OSM/LUM DECISION SHEET (DSH)

| Standard(s) (incl. year) | Subclause(s): | Tracking No. | Year |
|---|--|---------------------|-------------------------------|
| EN 60598-1:2015/A1:2018 EN 60570:2003/A1:2018 | General – 1.7 | DSH 0809A | 2019 |
| Fixed luminaire with track | - EN 60570 - 6,5 mm - Track system | OSM/LUM-ETF5 | 2019 ETICS Plenary Meeting |

Diagram A

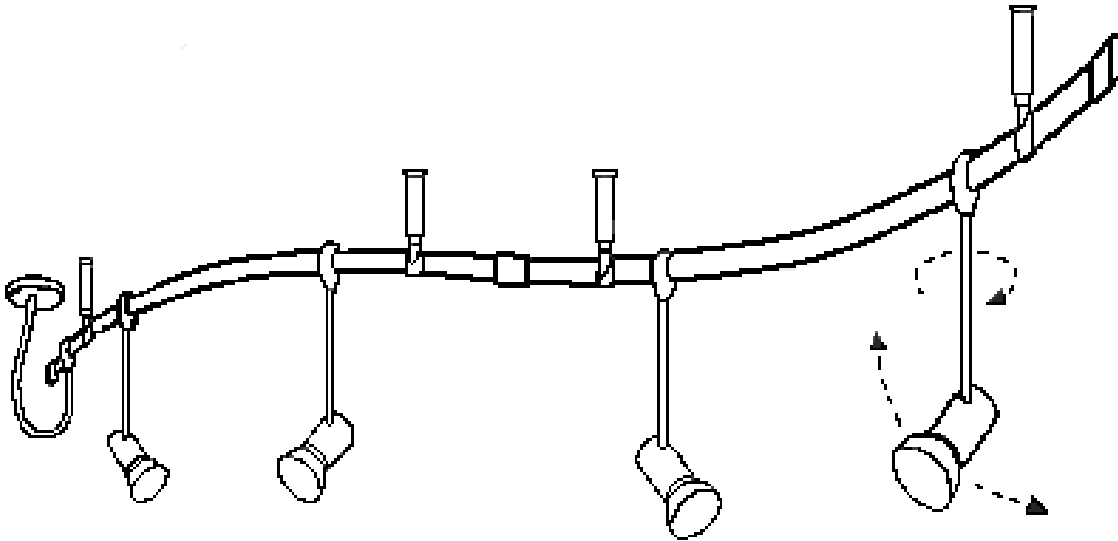
| Standard(s) (incl. year) | Subclause(s): | Tracking No. | Year |
|---|--|---------------------|-------------------------------|
| <p>1) To which standards should the product shown on the photo be tested?</p> <p>2) The product is class I because the ceiling cup is earthed. However most of the product including the track is Class II construction. We see from EN 60570 that class II track is not allowed. The product is intended for domestic use and not as a true track system as the scope of EN 60570. In this situation can a class II track be allowed?</p> <p>3) For a class II situation EN 60598-1 should be used (table 11.1 + Annex M item 2). What value creepage and clearance should be observed for the product shown on the photo?</p> | | | |

| Standard(s) (incl. year) | Subclause(s): | Tracking No. | Year |
|---|--|---------------------|-------------------------------|
| <p>1) EN 60570.</p> <p>2) No.</p> <p>3) As required for reinforced insulation.</p> | | | |
